Subject: Issuance of Amendment No.45 to Facility Operating  
License NPF-12 Virgil C. Summer Nuclear Station,  
Unit No. 1

The amendment modifies the Technical Specifications to reflect a 1.9% reduction in thermal design flow. The amendment is effective seven days after its date of issuance.

SAFETY EVALUATION BY THE OFFICE OF NUCLEAR REACTOR REGULATION  
RELATED TO AMENDMENT NO. 45 TO FACILITY OPERATING LICENSE NPF-12

Figure 2.1-1 Reactor Core Safety Limit - Three Loops in Operation

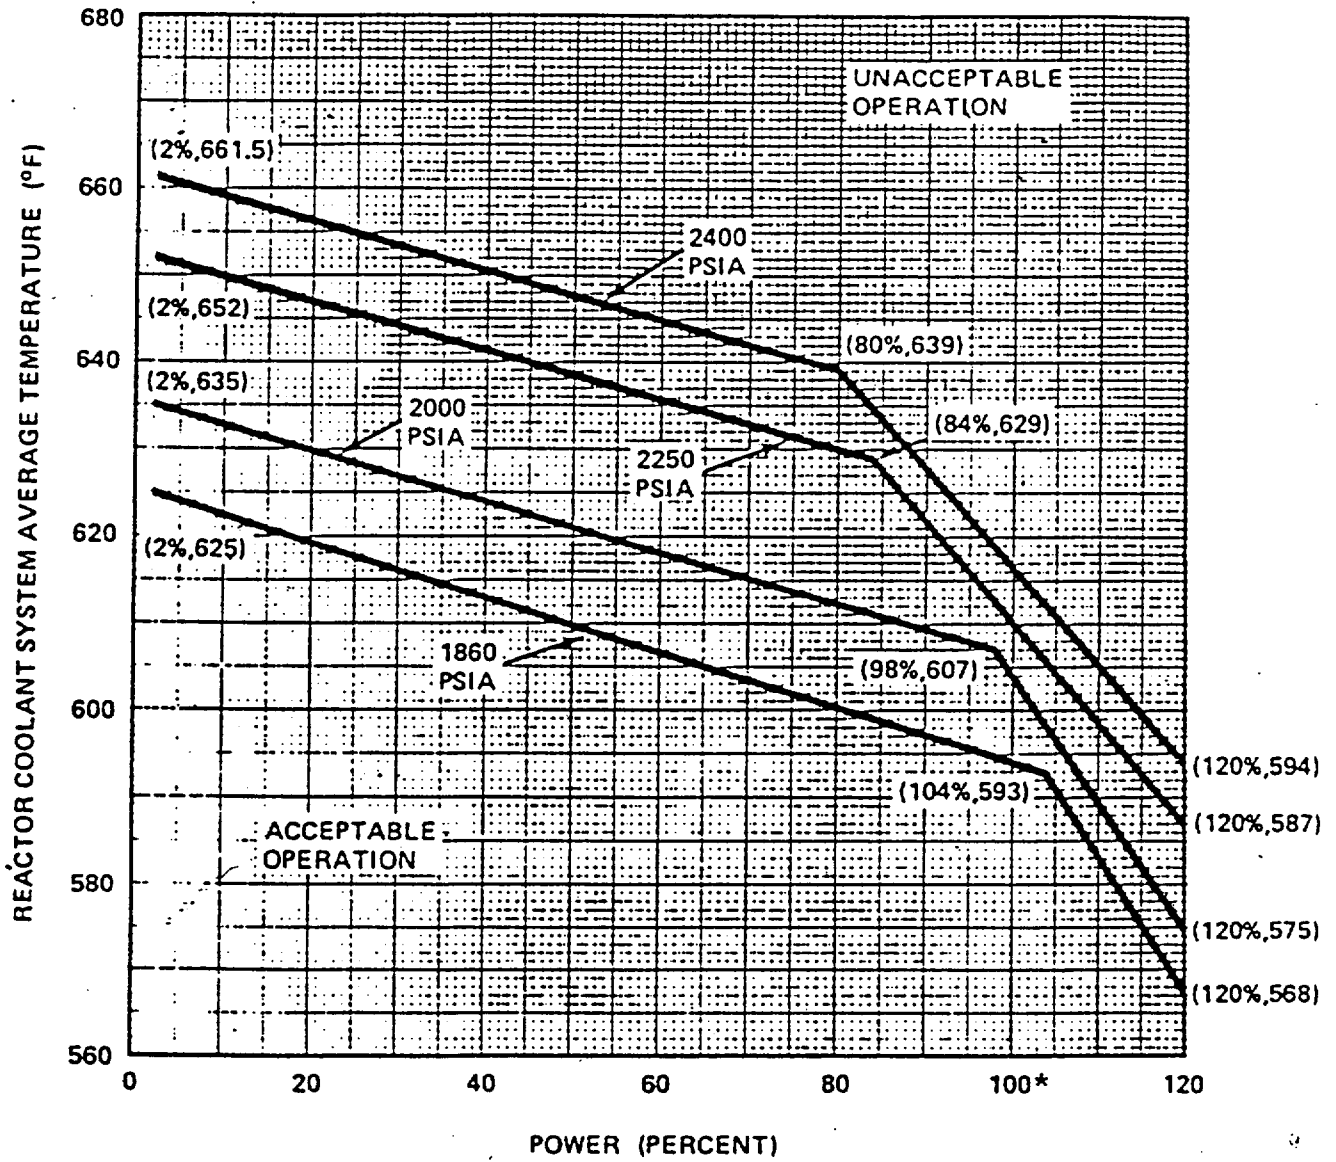
Changes in pages B3/4.2-4, B3/4.2-5, 3/4.2-8, 3/4.2-9, 2-2 and 3/4.2-11 are editorial. The changes are consistent with the changes related to the removal of dependence of operating band on rod bow penalty (as shown in Figure 3.2-3) and are acceptable.

\*When operating in the reduced RTP region of Technical Specification 3.2.3 (Figure 3.2-3), the restricted power level must be considered 100% RTP for this figure.

FIGURE 3.2-3 RCS TOTAL FLOW RATE VS. R THREE LOOP OPERATION

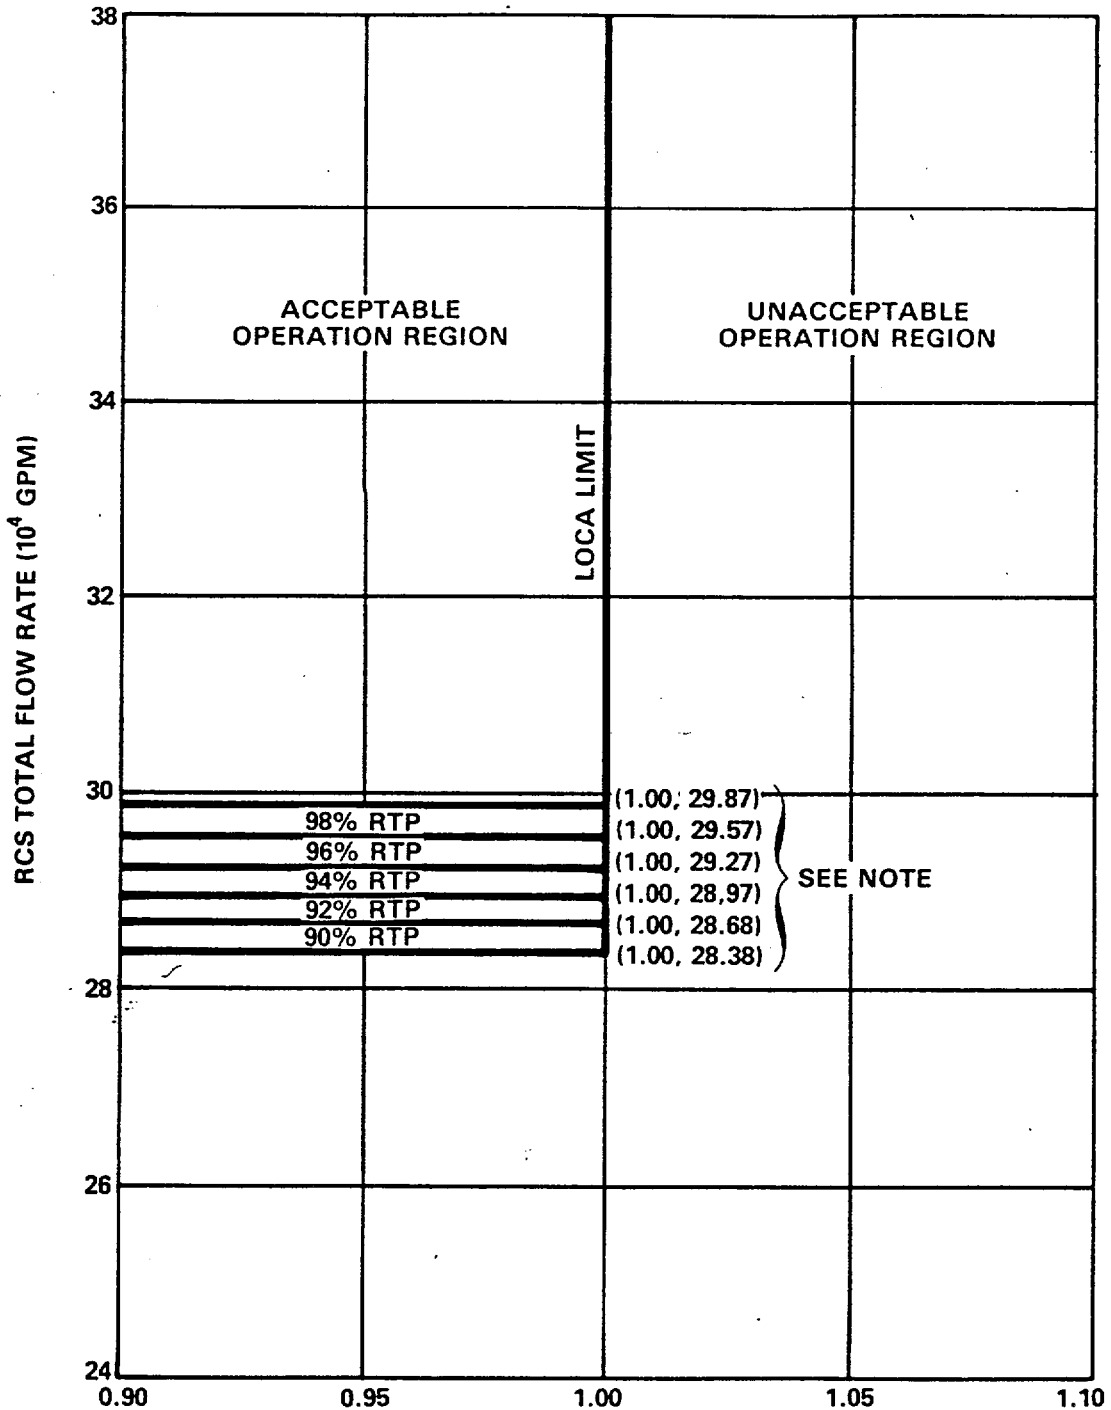
This figure has been modified to remove the operating area which has the dependence of operating power and reactor coolant flow on rod bow penalty. The changes cause the operating band to be more restrictive compared with the previously approved operating band and the changes are acceptable.

MEASUREMENT UNCERTAINTIES OF 3.5% FOR FLOW  
 AND 4.0% FOR INCORE MEASUREMENT OF  $F_{\Delta H}^N$  ARE  
 INCLUDED IN THIS FIGURE

NOTE: When operating in this region, the restricted power levels shall be considered to be 100% of rated thermal power (RTP) for Figure 2.1-1.
